2.5 Geology, Seismology, and Geotechnical Engineering

In Section 2.5, “Geology, Seismology, and Geotechnical Engineering,” of the site safety analysis report (SSAR), the applicant described the geological, seismological, and geotechnical engineering properties of the early site permit (ESP) site. SSAR Section 2.5.1, “Site and Regional Geology,” describes the basic geological and seismological data for the site and region surrounding the site. SSAR Section 2.5.2, “Vibratory Ground Motions,” describes the vibratory ground motion for the ESP site through a probabilistic seismic hazard analysis (PSHA) and develops the safe-shutdown earthquake (SSE) ground motion. SSAR Section 2.5.3, “Surface Faulting,” describes the potential for surface faulting at or near the surface of the ESP site. SSAR Section 2.5.4, “Stability of Subsurface Materials and Foundations,” presents information on the stability of the ESP site’s subsurface materials. SSAR Section 2.5.5, “Stability of Slopes,” defers the analysis of slope stability to the combined license (COL) application. Similarly, SSAR Section 2.5.6, “Embankments and Dams,” defers the reanalyses of the Clinton Power Station (CPS) ultimate heat sink

Figure 2.5.1-2 Schematic diagram showing the Reelfoot scarp and selected features in the area of the NMSZ

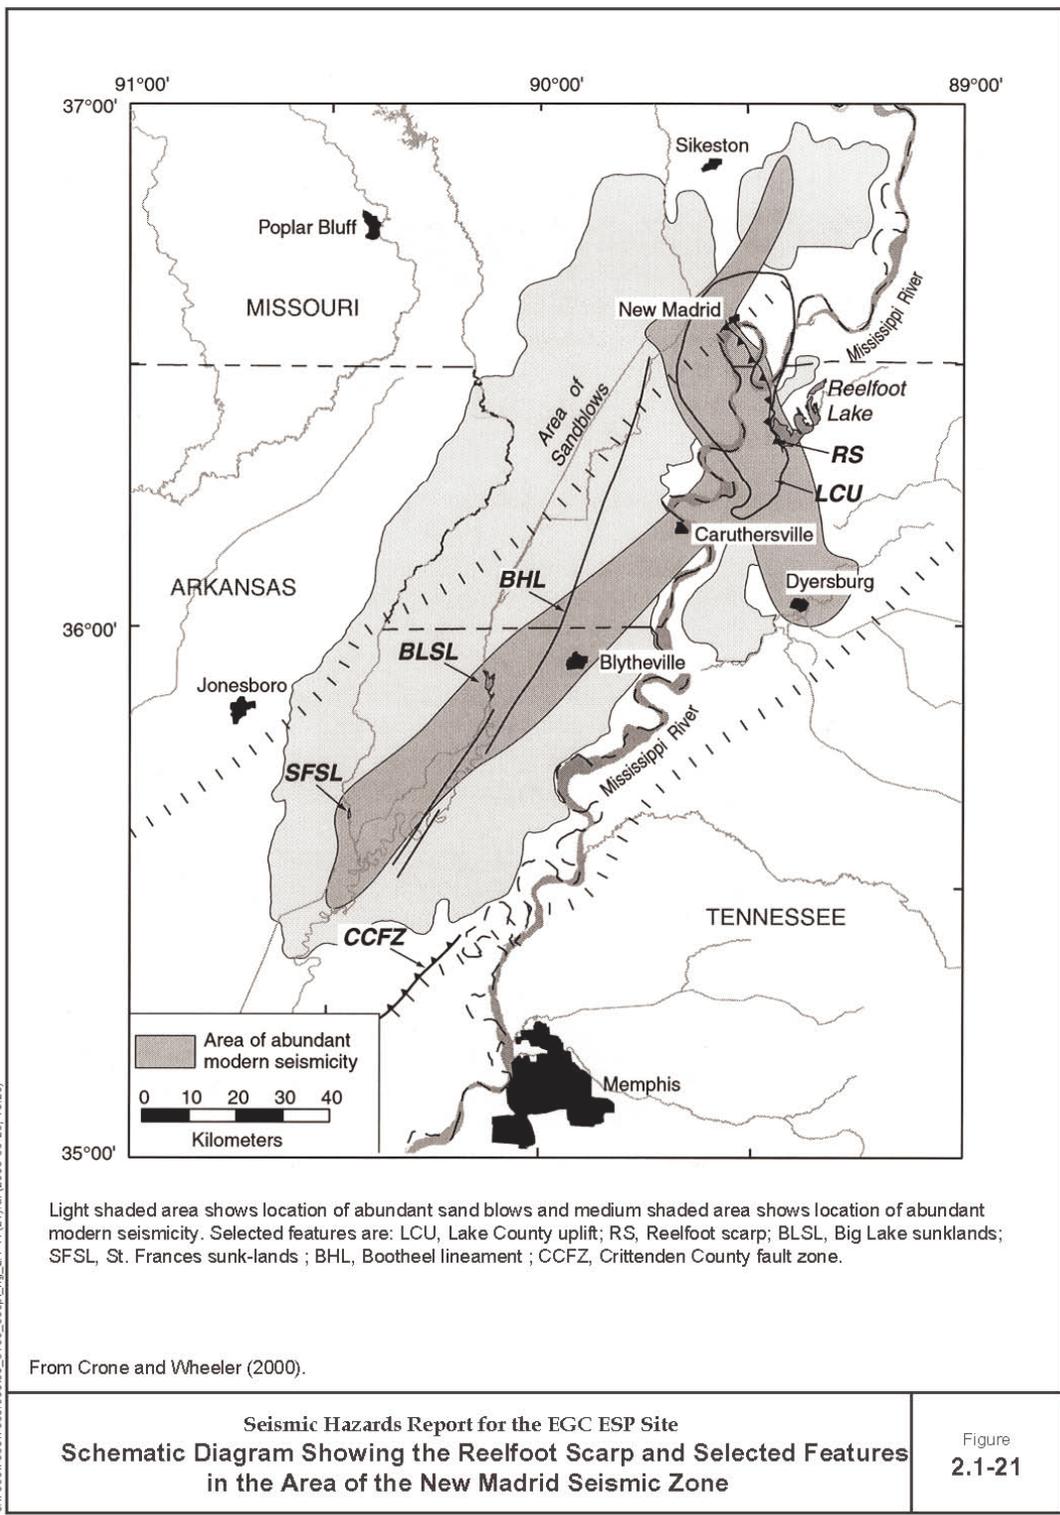
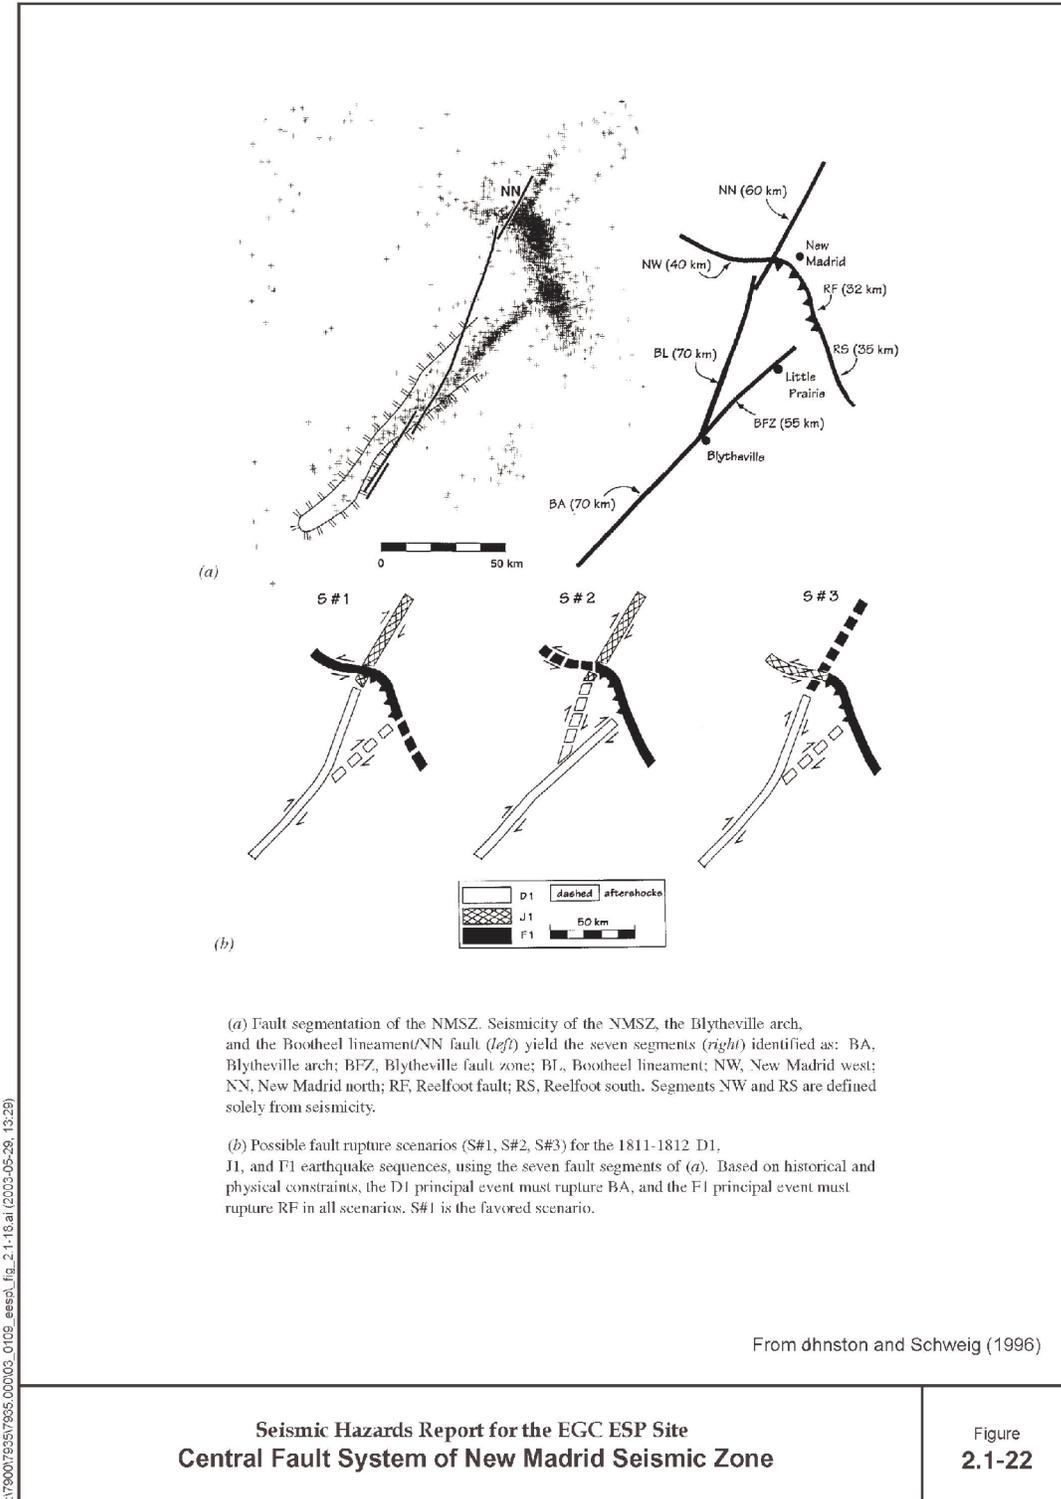
In Request for Additional Information (RAI) 2.5.1-1, the staff asked the applicant to clarify its magnitude estimates for the three 1811–1812 New Madrid earthquakes. In response, the applicant updated its magnitude estimates to include the latest research findings. Section 2.5.1.3.1 of this safety evaluation report (SER) provides further detail on the applicant's response to RAI 2.5.1-1 and the staff's evaluation of the applicant's response.

The staff considers the applicant's response to RAI 2.5.1-1 to be an adequate assessment of the latest geologic literature concerning the magnitudes for New Madrid characteristic earthquakes. The applicant revised its magnitudes for rupture set number 3 to reflect the changes made by Bakun and Hooper (2004). In addition, the applicant added two new models based on its review of the latest literature and communications with researchers. The applicant assessed the impact of these additions and revisions by reevaluating its PSHA and found an increase (3 to 4 percent) in the 1 Hertz (Hz) ground motion hazard curve at the mean 10^{-4} and mean 10^{-5} hazard levels. However, the applicant did not incorporate this new information into its PSHA or subsequent SSE ground motion spectrum and indicated that the ESP application did not need to be updated as a result of its response to RAI 2.5.1-1. In Open Item 2.5.1-1, the staff asked the applicant to incorporate this information into its PSHA or SSE and to update the SSAR to reflect the corrected magnitude estimates. In response, the applicant updated its source characterization of the New Madrid earthquakes including the final published assessments of Bakun and Hooper (2004). These changes have been incorporated into the ESP application. Therefore, the staff considers Open Item 2.5.1-1 to be resolved.

Figure 2.5.1-5 Map showing surveyed stream banks and evidence for paleoliquefaction in the site vicinity

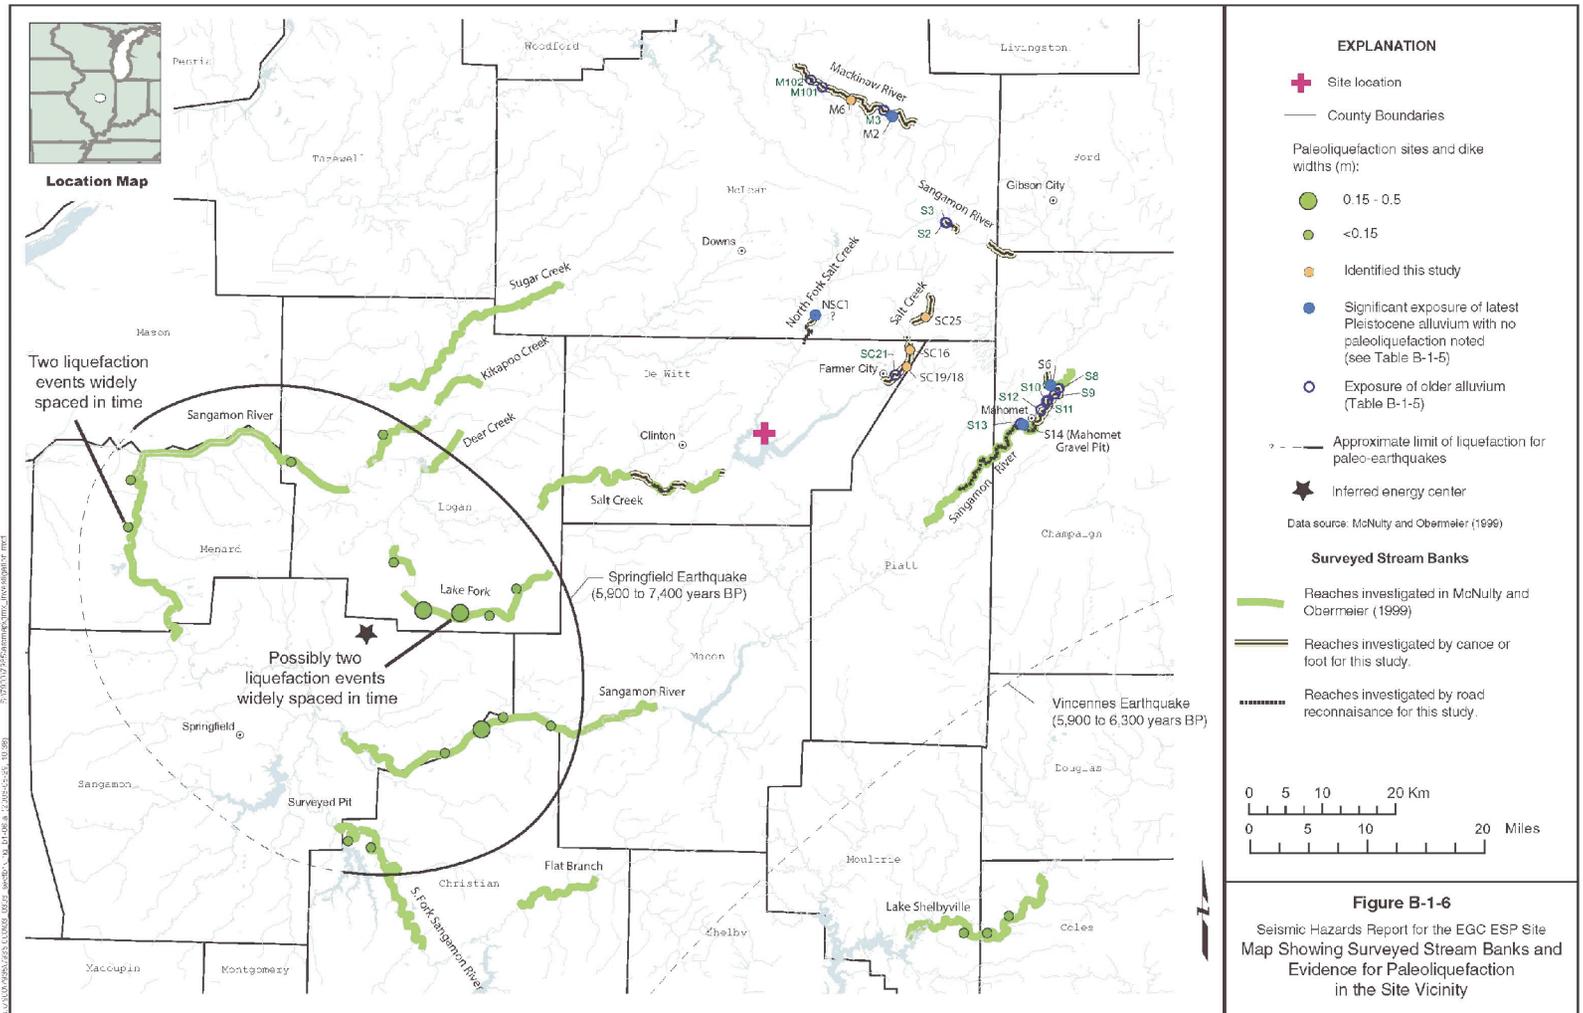
In RAI 2.5.2-6, the staff asked the applicant to explain its selected paleoliquefaction study area along the streams near the ESP site. Specifically, the staff asked the applicant why it did not examine the streams northwest and southeast of the site as part of its study. In response, the applicant stated that it selected its study area to supplement previous liquefaction studies along portions of the Sangamon River, portions of Salt Creek, and similar drainages west and northwest of the site. SER Section 2.5.1.3.1 provides further detail on the applicant's response to RAI 2.5.2-6 and the staff's evaluation of the applicant's response.

In RAI 2.5.1-4, the staff asked the applicant to provide better annotated photographs of the liquefaction features found along the Salt Creek. In response, the applicant provided photographs that clearly indicate the locations of the sand dikes. In RAI 2.5.1-5, the staff asked the applicant to substantiate the reliability of its methods to determine the size and location of paleoearthquakes based on liquefaction features. In response, the applicant demonstrated how it used the paleoliquefaction data and analyses to characterize the regional and local seismic potential of these paleoearthquake centers. SER Section 2.5.1.3.1 provides further detail on the applicant's response to RAIs 2.5.1-4 and 2.5.1-5 as well as the staff's evaluation of these responses.

Based on its review of the applicant's response to RAI 2.5.2-6, the staff concludes that the applicant adequately surveyed the site area for liquefaction features. The staff concurs with the applicant's conclusion that the few liquefaction features indicate that there has not been a paleoearthquake comparable to the Springfield earthquake in the site area during the past 6000 to 7000 years. An earthquake of this size (M 6.2 to 6.8) would most likely have produced liquefaction features along many of the stream banks in the site area that were examined by the applicant. In addition, the staff finds that the applicant has conservatively modeled the seismic potential of the site area by defining a broad areal seismic source zone (Illinois basin/background) as part of its PSHA.

Figure 2.5.2-6 Comparison of performance-based SSE spectrum for the ESP site and the mean 10⁻⁴ and 10⁻⁵ UHRS

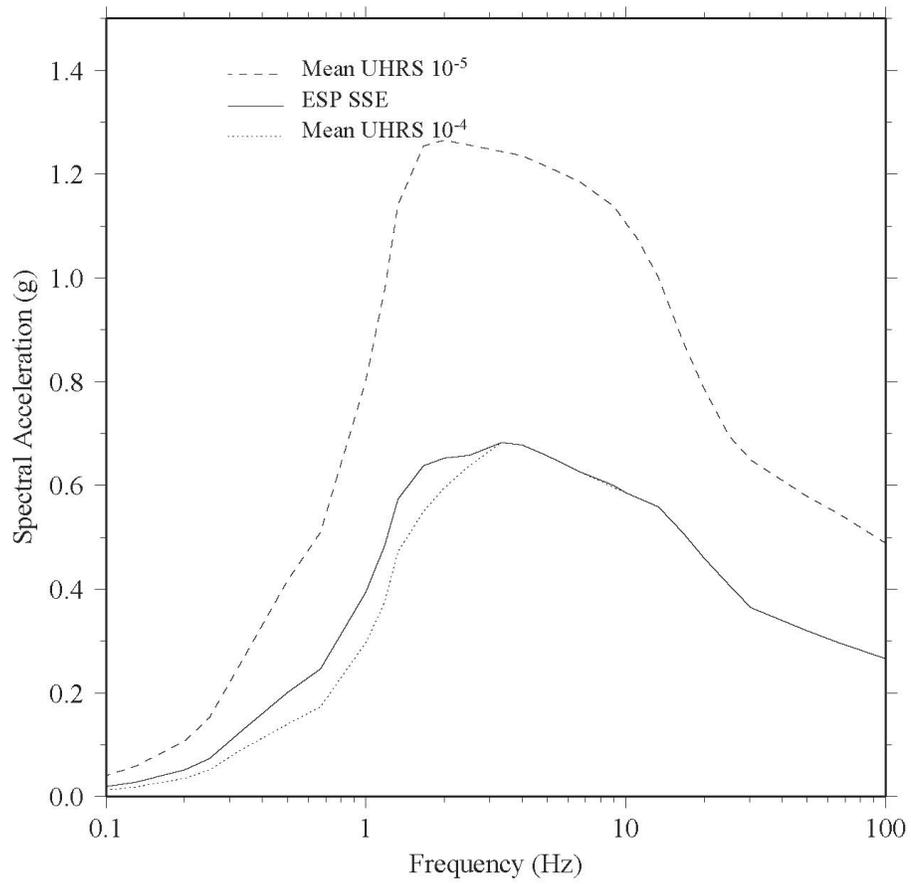
In RAI 2.5.2-1(a), the staff asked the applicant to justify the selection of the site-specific mean 10^{-4} UHRS as the appropriate starting point for determining the final SSE. In response to RAI 2.5.2-1(a), the applicant stated that the “design amplitude required to achieve the performance goal at each structural period can be calculated starting from the mean 10^{-4} annual probability level of the seismic hazard spectrum in the free field at the ground surface, or from the 10^{-5} annual probability level, or from any intermediate probability level.” The applicant explained that it selected a 10^{-4} annual probability level as the starting point based on the precedent set in ASCE/SEI Standard 43-05.

In RAI 2.5.2-1(b), the staff asked the applicant to demonstrate that the SSE envelops the site-specific response spectra from the controlling earthquakes at the reference probability level (median 10^{-5} per year) recommended by RG 1.165 or to justify why this approach was not used to determine the SSE. In response to RAI 2.5.2-1(b), the applicant stated that it did not rely on the site-specific response spectra from the controlling earthquakes at the hazard reference probability level of median 10^{-5} per year to determine the site-specific SSE. Instead, the applicant used the performance-based approach in ASCE/SEI Standard 43-05 to determine the site-specific SSE.

In RAI 2.5.2-1(c), the staff asked the applicant to justify using SSC seismic fragility information, before the selection of a reactor design, to determine the site SSE. In response to RAI 2.5.2-1(c), the applicant stated that the performance-based approach “combines a conservative characterization of equipment/structure performance with ground motion hazard to establish risk-consistent SSEs, rather than only hazard-consistent ground shaking, as occurs using the hazard reference probability approach in Appendix B of RG 1.165.”

Figure 2.5.2-7 Four mean seismic hazard curves (1 Hz, 2.5 Hz, 5 Hz, and 10 Hz) for EGC ESP site plotted on a log-log scale. Dashed lines indicate annual probability of exceedance intervals of 10^{-4} per year and 10^{-5} per year.

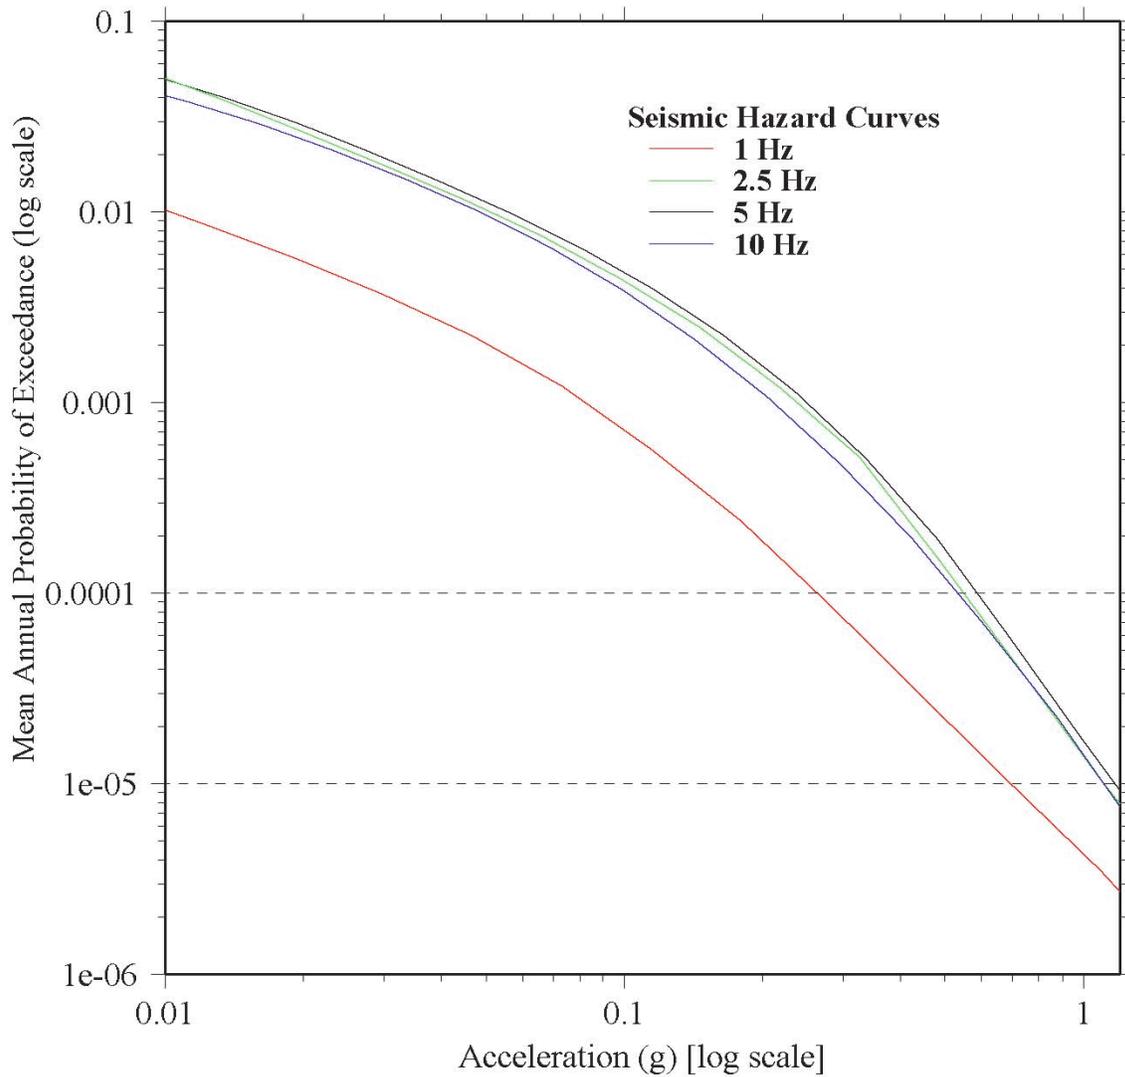
Linear Hazard Equation. In Open Item 2.5.2-5(a), the staff asked the applicant to justify the assumption of a linear hazard curve in logarithmic space (see Equation 2.5.2-13 and Figure 2.5.2-7) and the appropriateness of solely using the 10^{-4} to 10^{-5} interval to determine the amplitude ratio A_R and, as such, the DF. In response, the applicant stated the following:

In addition, the applicant stated that “based upon several hundred rigorous convolutions of hazard and fragility curves, it has been found that P_{FT} is dominated by the portion of the fragility curve between about the 1% failure probability capacity $C_{1\%}$ and the 70% failure probability capacity $C_{70\%}$ ” (see Figure 2.5.2-11 for an illustration of this portion of the fragility curve). The applicant also compared SSE values obtained by direct integration of the risk integral (Equation 2.5.2-9), which uses the entire hazard and fragility curves, versus the those obtained by using the risk equation (Equation 2.5.2-1), which assumes a linear hazard curve in log-log space between the exceedance frequencies of $1 \times 10^{-4}/\text{yr}$ to $1 \times 10^{-5}/\text{yr}$. Comparing the two results, the applicant stated, “one can see that the use of the approximate power law hazard curve introduces a slight, but generally negligible, conservative bias for the computed P_{FT} .”

Since the seismic hazard curves have a slight downward curvature, as illustrated in Figure 2.5.2-7, assuming a linear fit results in slightly higher exceedance values and, as a result, slightly higher SSE values, as illustrated above in Table 2.5.2-4. Therefore, the staff concludes that the applicant’s use of the approximate power law hazard curve is slightly conservative and therefore acceptable.

Figure 2.5.2-14 Comparison of exact and approximate DF . Exact DF varies with both A_R and β , while approximate DF depends only on A_R .

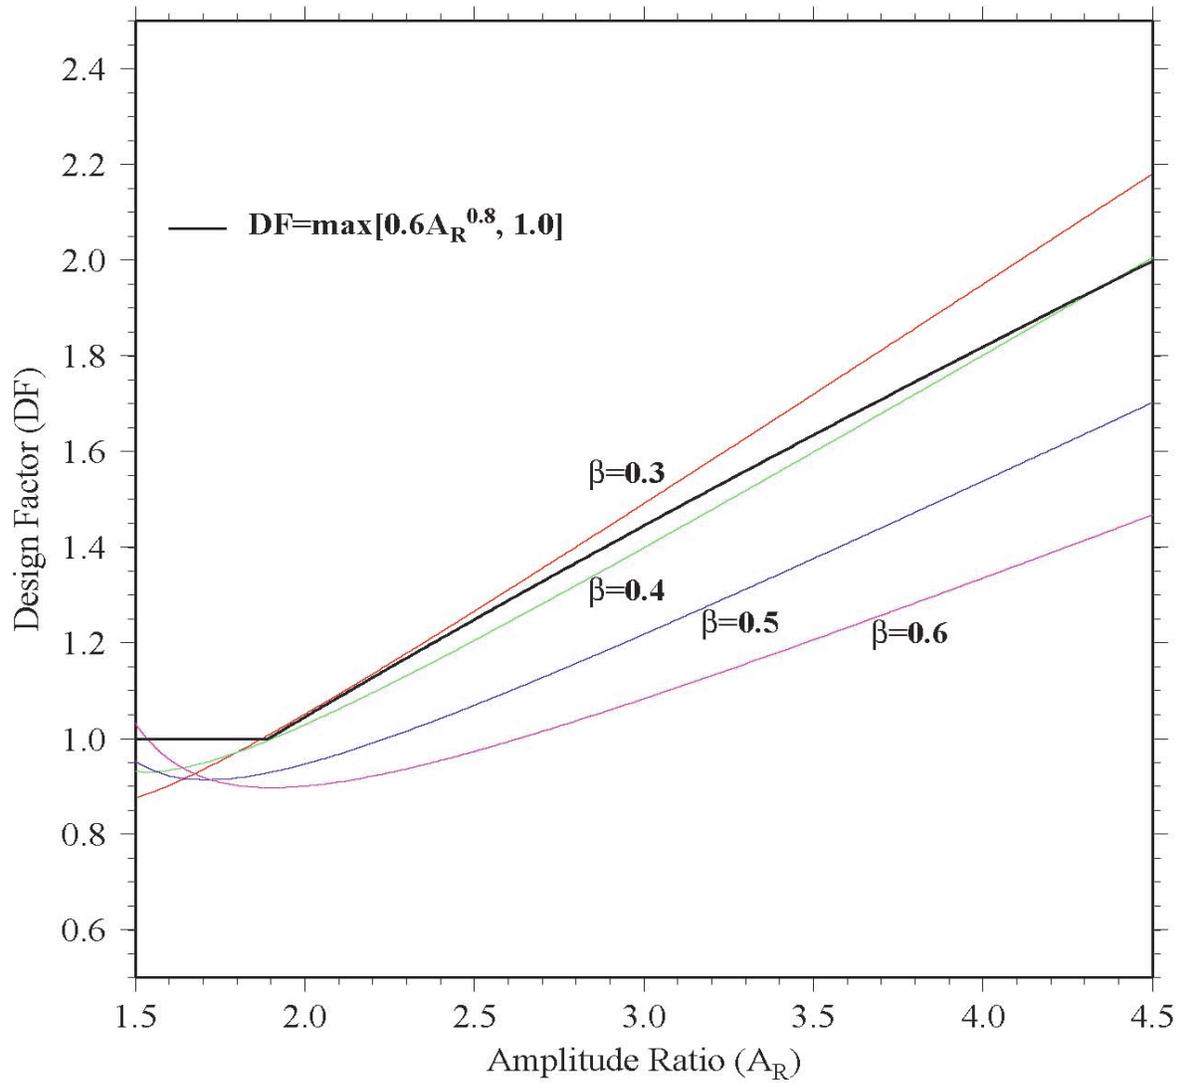
As shown previously in Figure 2.5.2-14 in Section 2.5.2.1.6.1, the DF recommended in ASCE/SEI 43-05 (Equation 2.5.2-1) is slightly unconservative for $\beta=0.3$ and conservative for larger β of 0.4 to 0.6. To evaluate the significance of the range of β values on the DF, the staff determined the unacceptable performance frequency values (P_{FT}) for the performance-based SSE values for four natural frequency values 1, 2.5, 5, and 10 Hz. The applicant determined the four performance-based SSE values shown below in Table 2.5.2-5 using the performance-based approach as described in ASCE/SEI 43-05, which assumes a β value of 0.4 and a target performance goal of $1 \times 10^{-5}/\text{yr}$. The staff used the four hazard curves provided by the applicant to determine P_{FT} via direct integration of the risk integral (Equation 2.5.2-9) for β ranging from 0.3 to 0.6. As shown below in Table 2.5.2-5, the P_{FT} values for $\beta=0.3$ are only slightly larger than the target value of $1 \times 10^{-5}/\text{yr}$.
